**4<sup>th</sup> Further Information**

**Proposed Temporary Warehouse (excluding Dangerous Goods Godown) with Ancillary Facilities  
for a Period of 3 Years and Associated Filling of Land and Pond in "Agriculture" Zone,  
Lot 1291 (Part) in D.D. 107, Fung Kat Heung, Kam Tin, Yuen Long, New Territories**

**(S.16 Planning Application No. A/YL-KTN/1004)**

Drainage Appraisal

DRAWING NUMBER  
**FIGURE 3C**

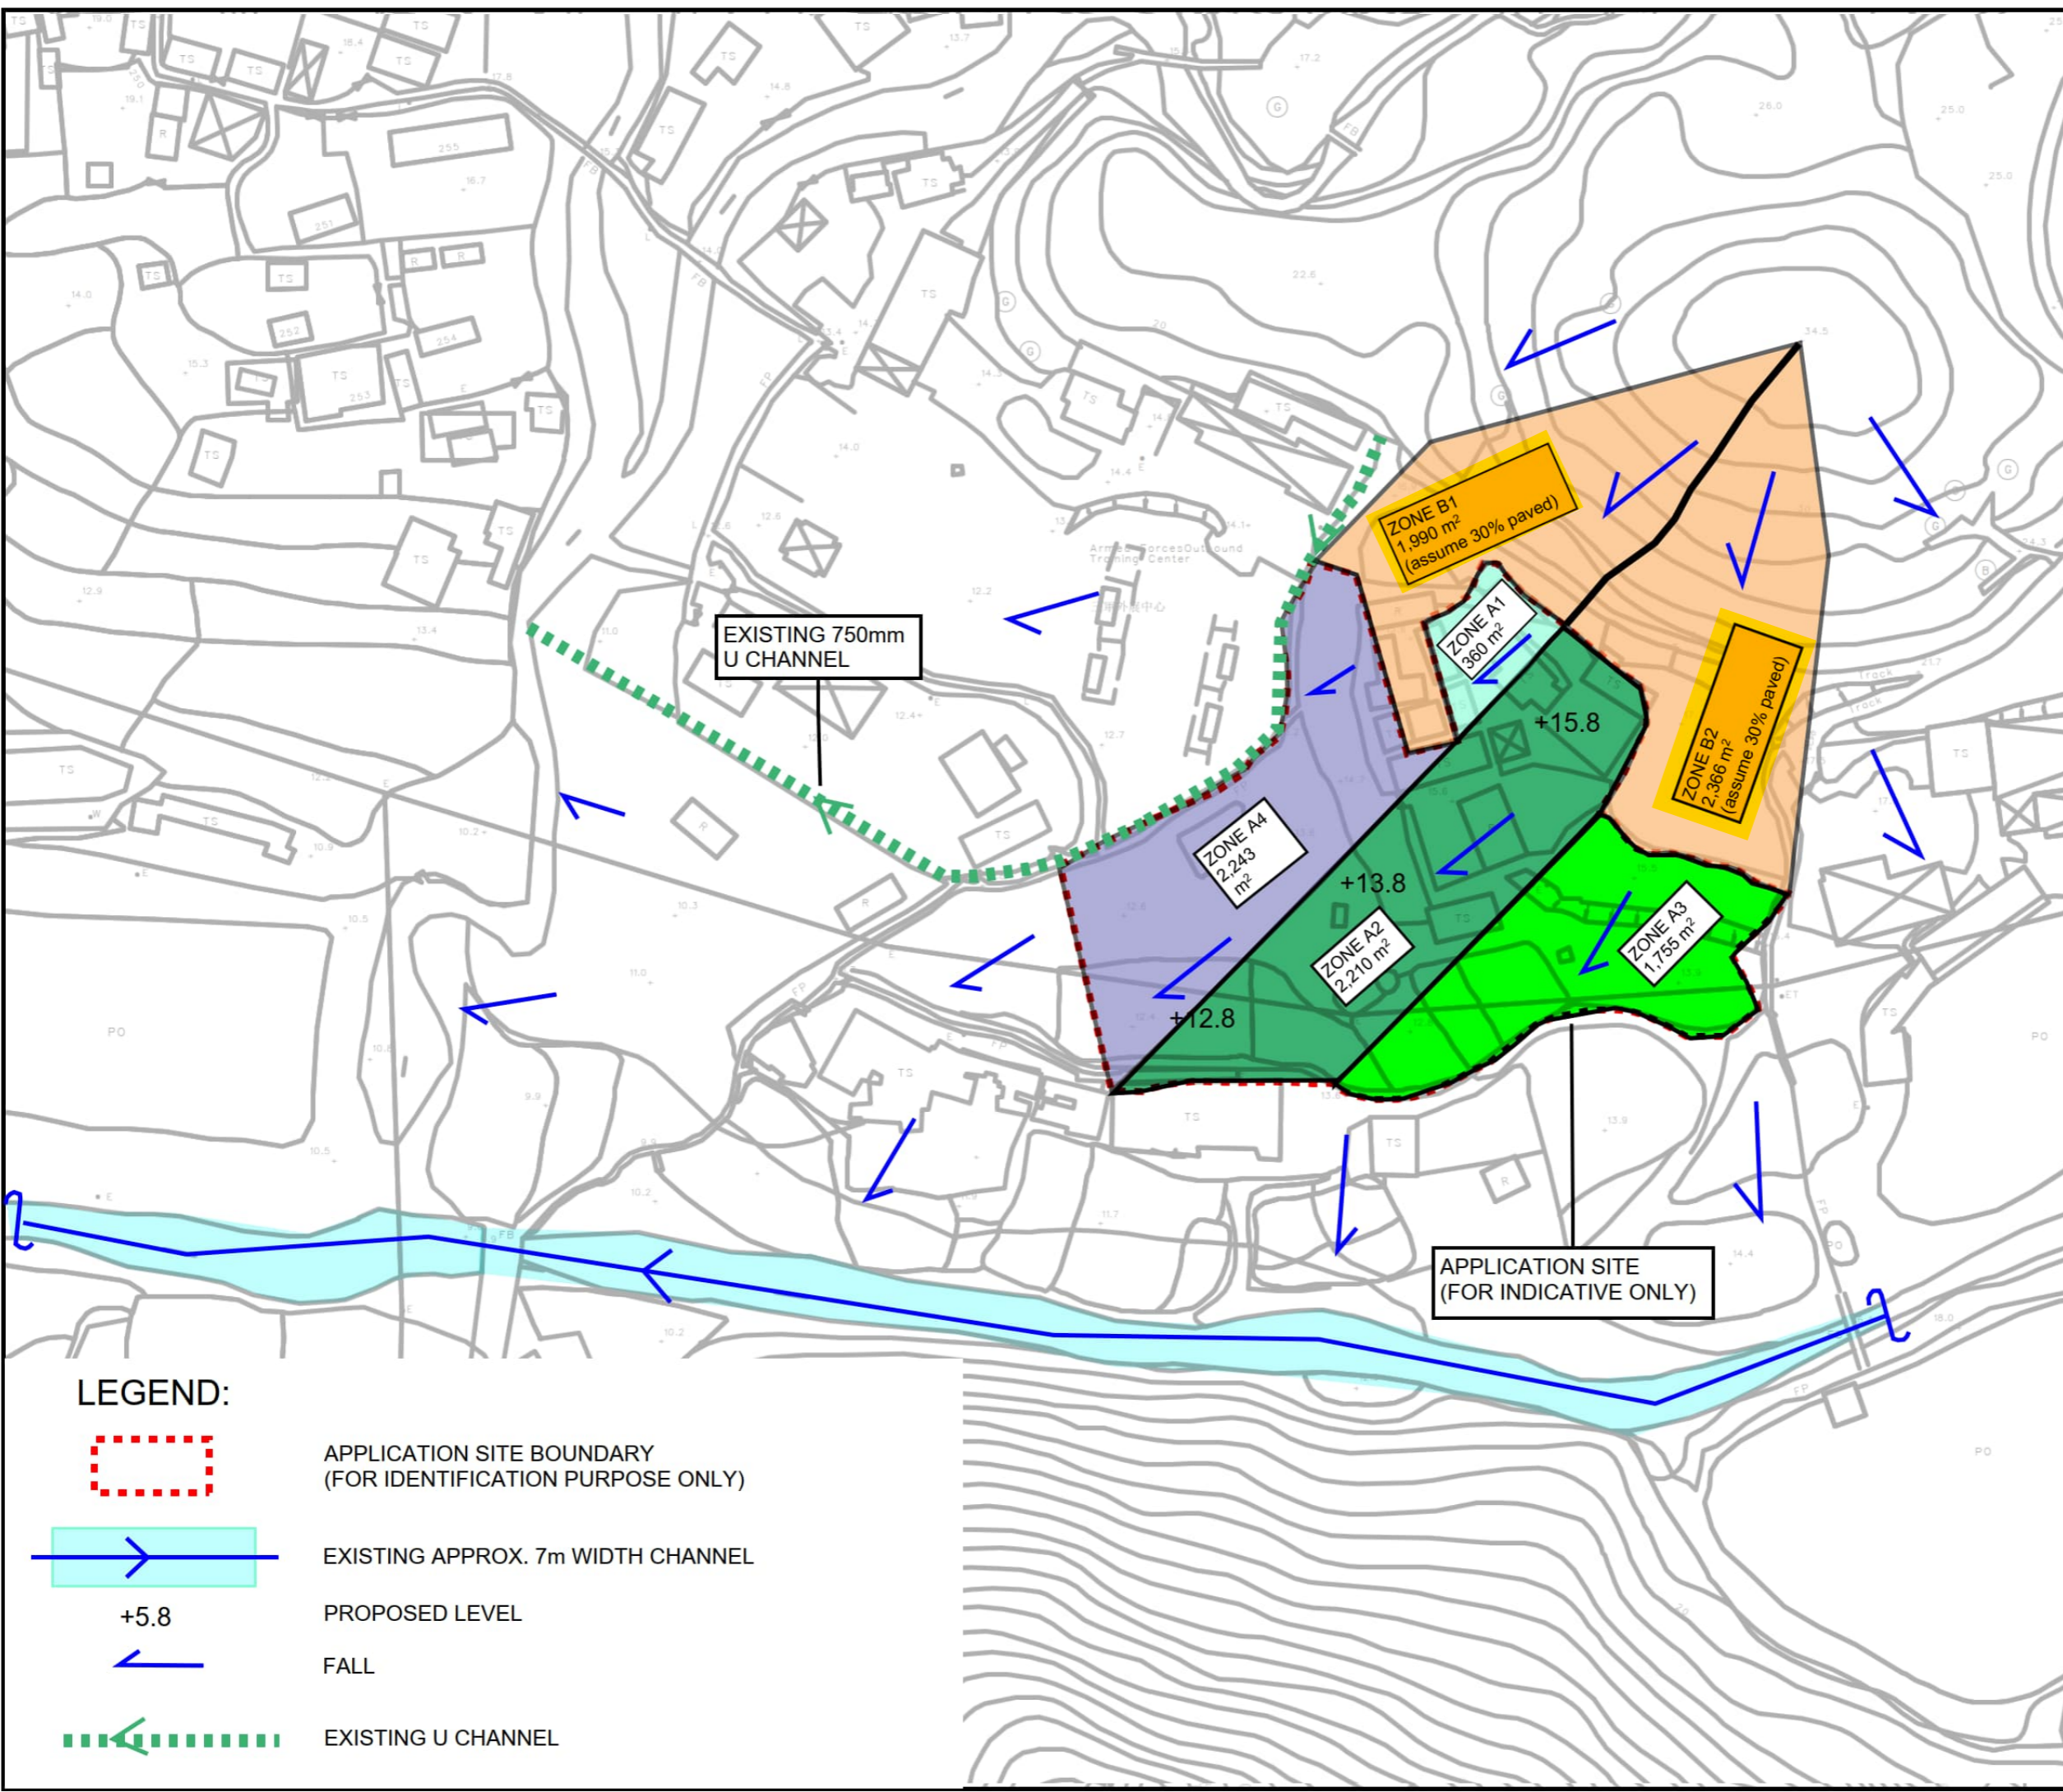
(a)	Please add the R-to-C in the report text and also drawing.	Noted. Please refer to Section 4.1.2 in the report and <b>Figure 3C</b> .
(b)	Please submit a full report with all R-to-C record included as appendix for reference.	Noted. Please refer to the updated full report ( <b>Annex I</b> ).
<b>2. Comments of the Chief Town Planner/Fanling Sheung Shui and Yuen Long East, Planning Department (DPO/FSYLE, PlanD)</b> <b>(Contact Person: Ms. Olivia NG; Tel.: 3168 4045)</b>

Item	Comments	Responses
1	Please add the R-to-C (c) in the report text and also the drawing.	Noted. Please refer to Section 4.1.2 in the report and Figure 3C.
2	Please submit a full report with all R-to-C record included as appendix for reference.	Noted. Please refer to the updated full report.

SECTIONS

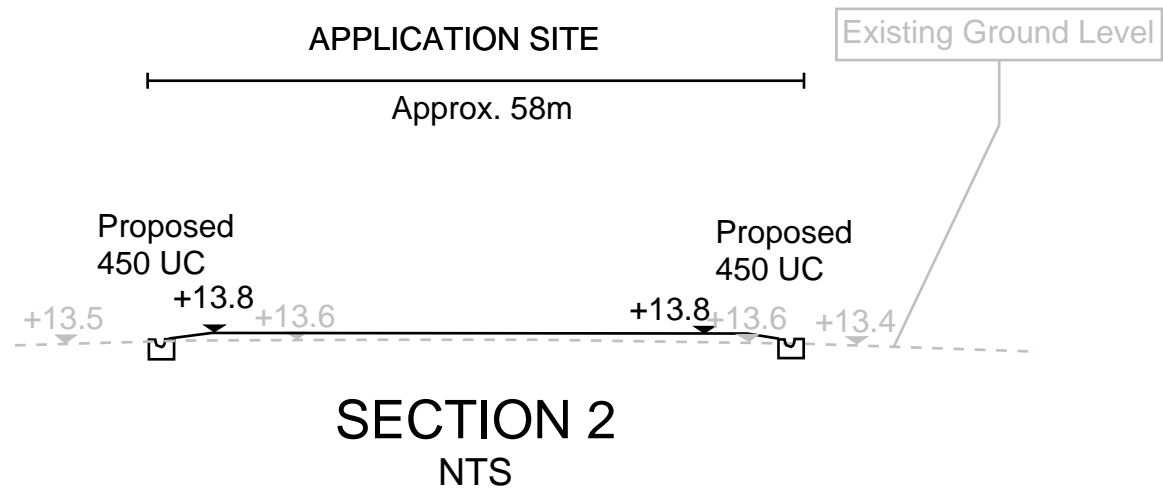
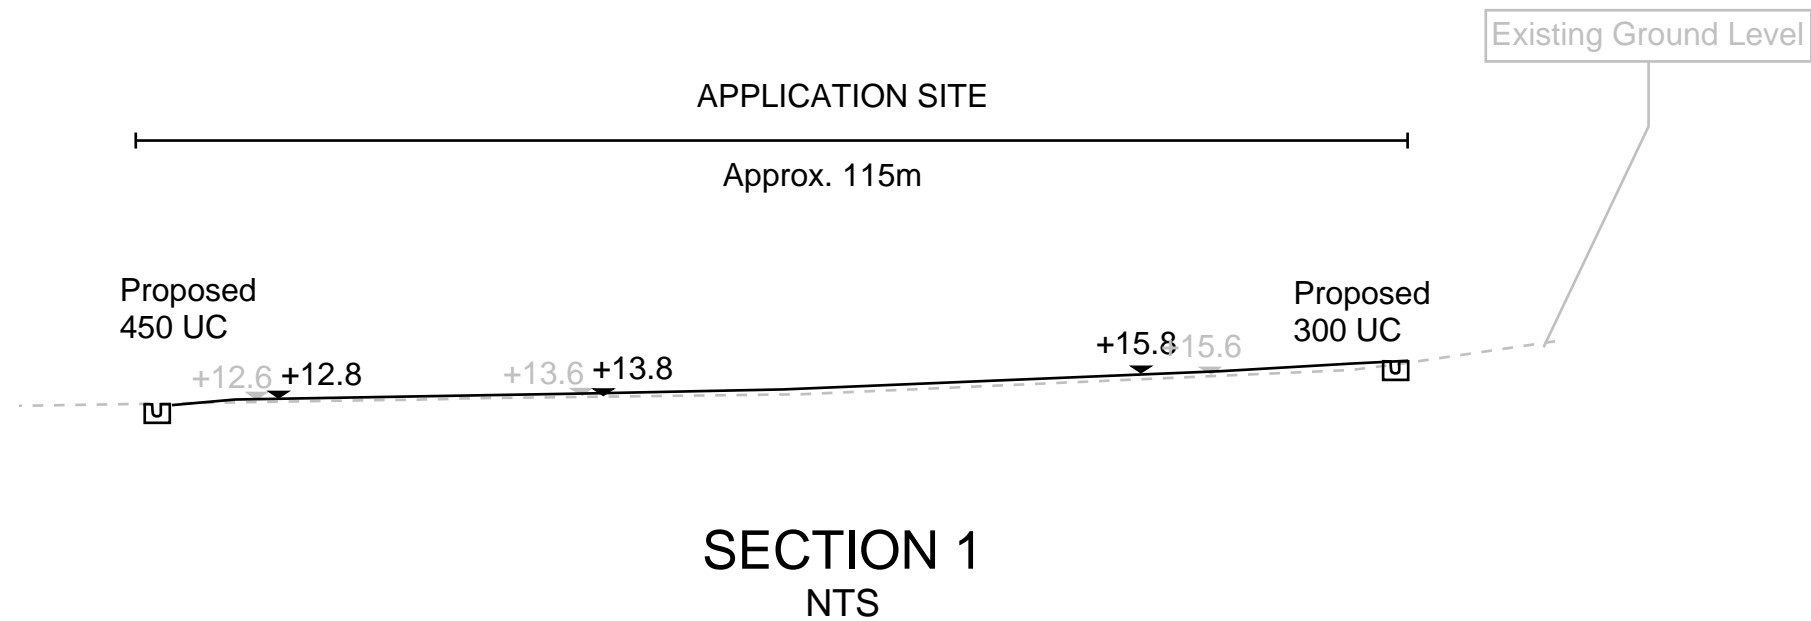
4	Cross sections: Adjacent ground levels should be shown on drawings. The extent of north area in Section 2 should also be included.	Noted. Please refer to the revised Appendix D.
5	Design Calculation: Please show the detailed calculation steps of proposed u-channels.	Noted. Please refer to the updated Appendix A.

## Appendix E Checking of Existing 7m (W) x 3m (D) Channel [Assume width of channel is 3m for Assessment Purpose]

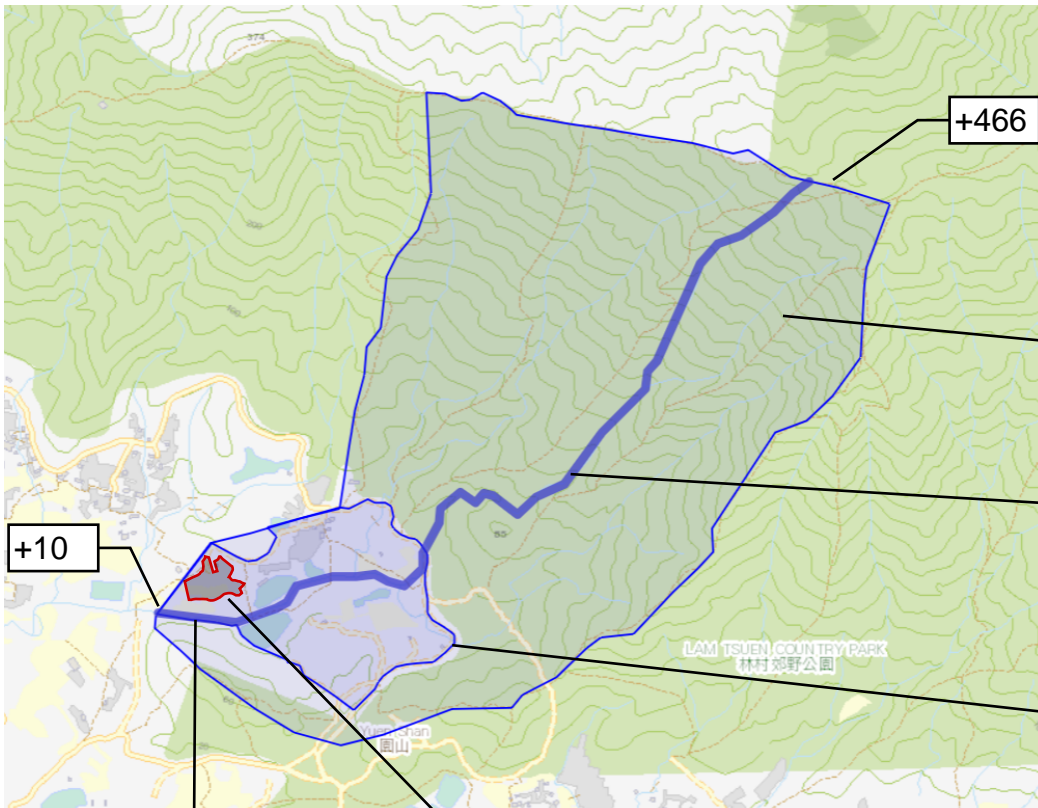
(e)	Please submit calculation demonstrating the downstream drainage system receiving the discharge from the development has adequate spare capacity to accommodate the runoff.	Noted. Please refer to Appendix E showing the calculation of downstream drainage.
